TfNSW Reference: SYD25/00115/02
DPHI Reference: SSD-65924461

**ENVIRONMENTAL IMPACT STATEMENT EXHIBITION - WAREHOUSE AND DISTRIBUTION CENTRE
49-61 STEPHEN ROAD, BANKSMEADOW**

TAB A

1. Traffic Impact Assessment (TIA) comments

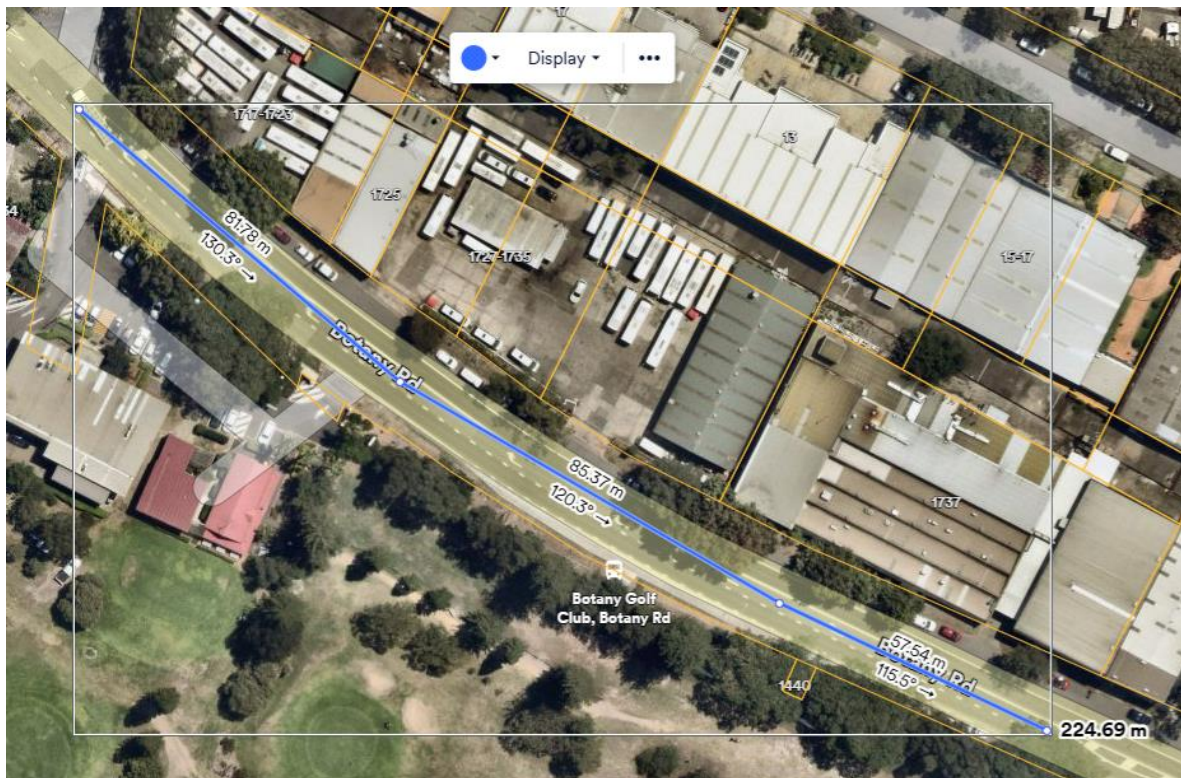
- iv) The cycle times modelled for the two signalised intersections appear incorrect. Please confirm the cycle times on the day of the survey as a review of SCATS plan data indicates the following cycle times:
